**LEGAL ADVERTISEMENT
HISTORIC PRESERVATION BOARD
CITY OF PORTLAND
Public comments will be taken at all meetings**

**HISTORIC PRESERVATION BOARD
CITY OF PORTLAND, MAINE**

**PUBLIC HEARING
251 and 261 COMMERCIAL STREET**

Application For: Certificate of Appropriateness for Elevated Building Connector

South Elevation

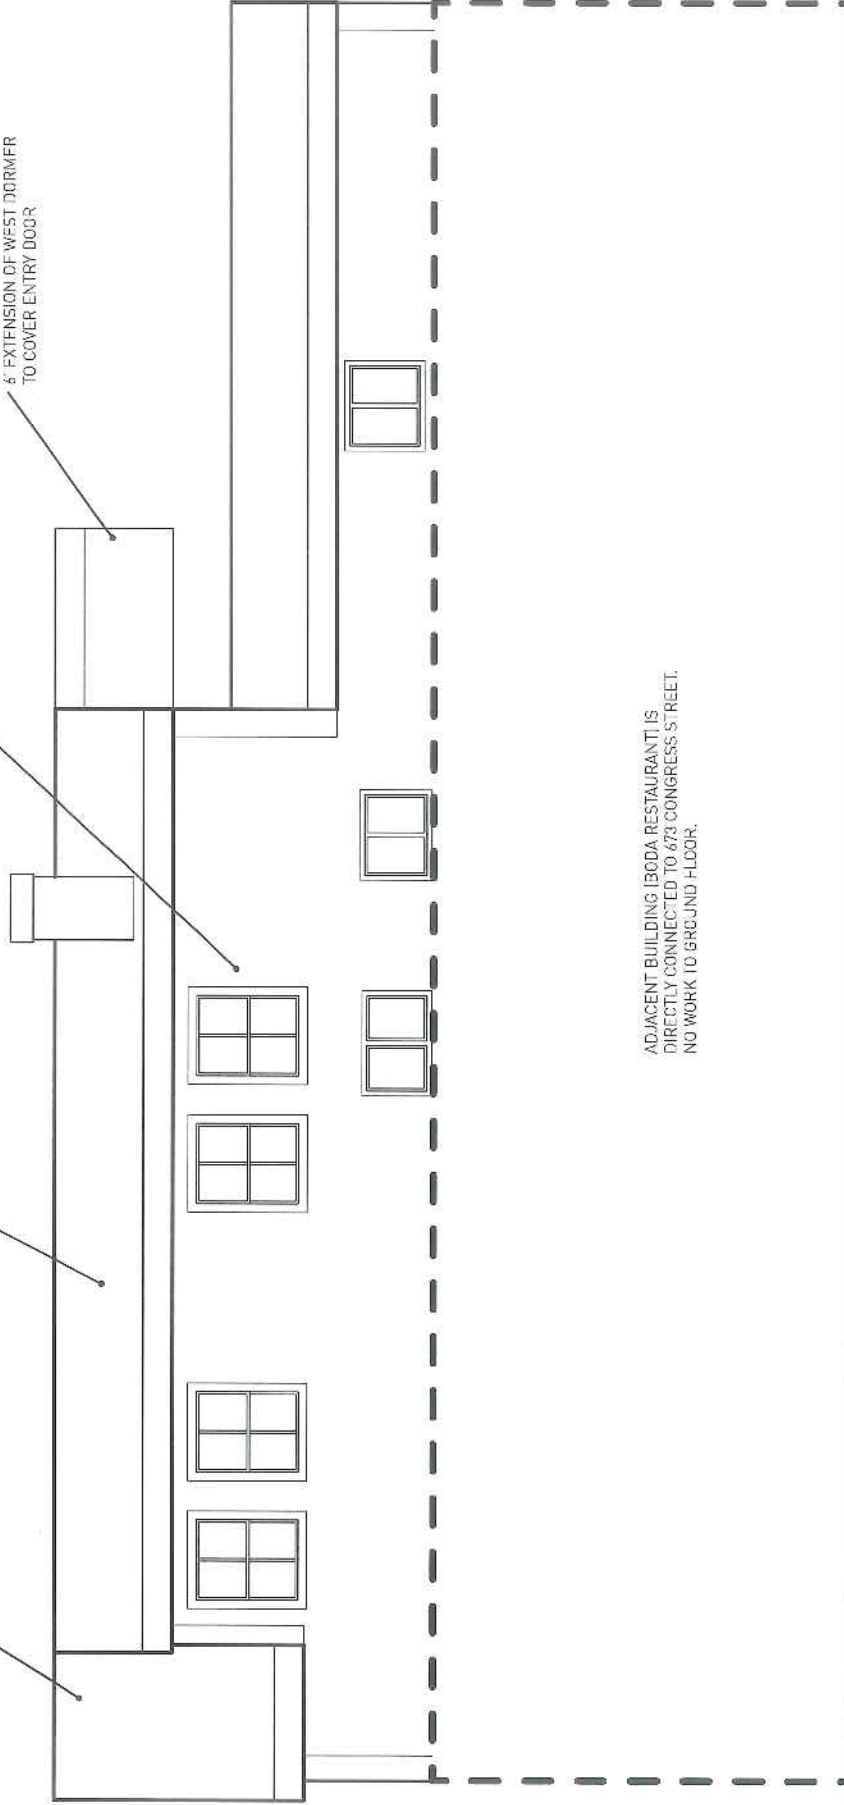
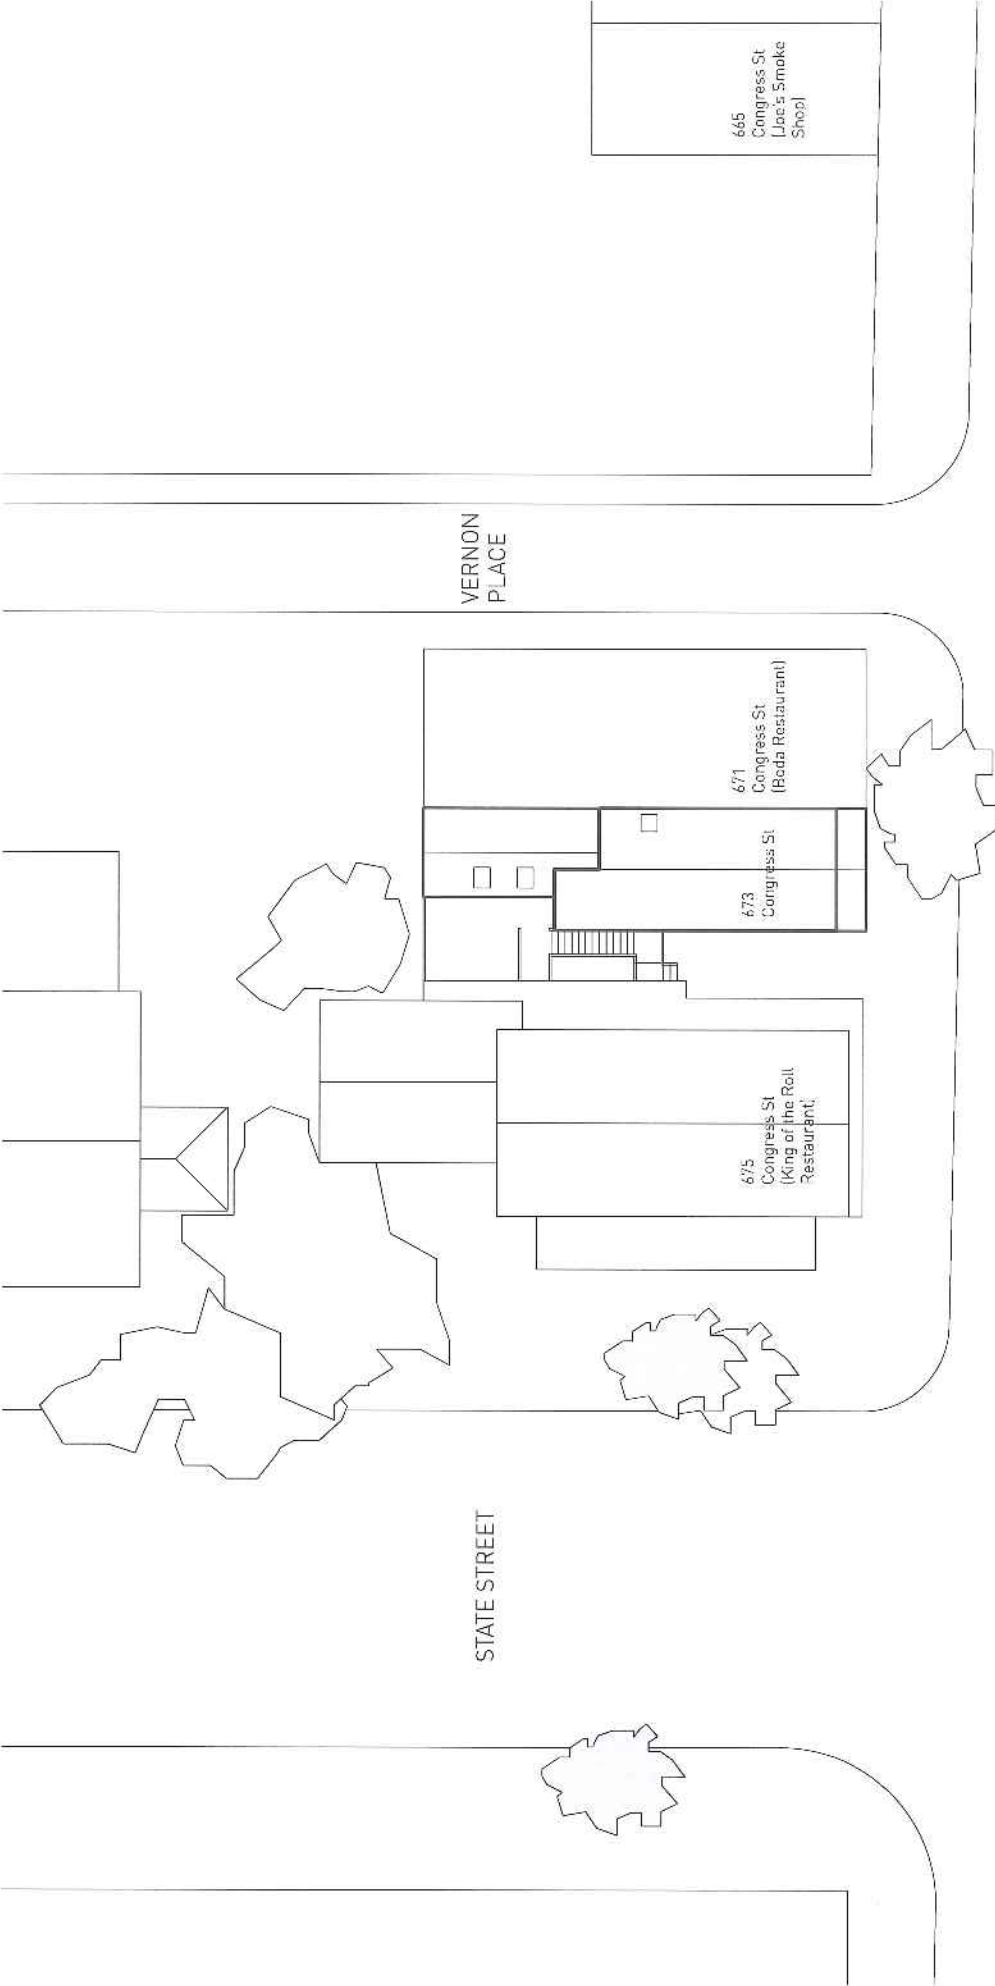
As of this writing, some details remain to be resolved. Mr. Doukas recently engaged an architecture student to create drawings, but staff remains unclear at this time exactly how the dormer construction is proposed to affect the main roof, the height of the ridge, and the wall height (and corresponding window height) of the dormers. Staff believes the applicant might be supplying revised drawings at next week’s Board meeting, and has advised Mr. Doukas to come prepared to clearly explain the plans.

DORMER SET BACK 4' FROM
THE STREET ELEVATION

6' EXTENSION OF WEST DORMER
TO COVER ENTRY DOOR
